URGENT FIELD SAFETY NOTICE

GEHC Ref# 36131

RE: **Dash 3000/4000/5000, Solar 8000M/i, and Solar 9500 patient monitors may restart due to network overload situation caused by network misconfiguration**

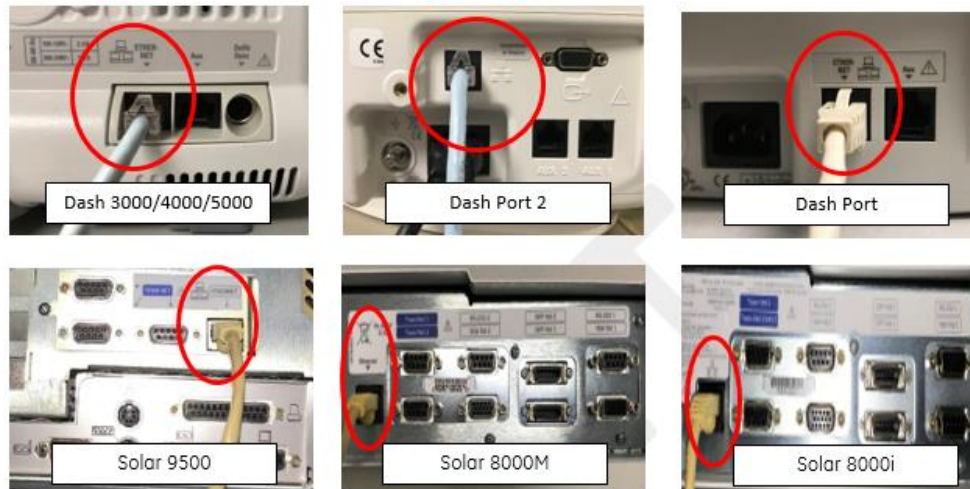
During the automatic restart cycle:

- The system will display a restart screen on the bedside monitor and the monitors will provide an extended audible tone during the restart.
- The CIC Pro Clinical Information Center and CARESCAPE Central Station will display a No Communication, "NO COMM", message.

After the restart completes, the monitors return to normal monitoring automatically. This includes the availability of trends and data collected previously as well as regaining network connection to central monitoring. The CIC Pro Clinical Information Center and CARESCAPE Central Station will also have the capability to provide historical data and trends.
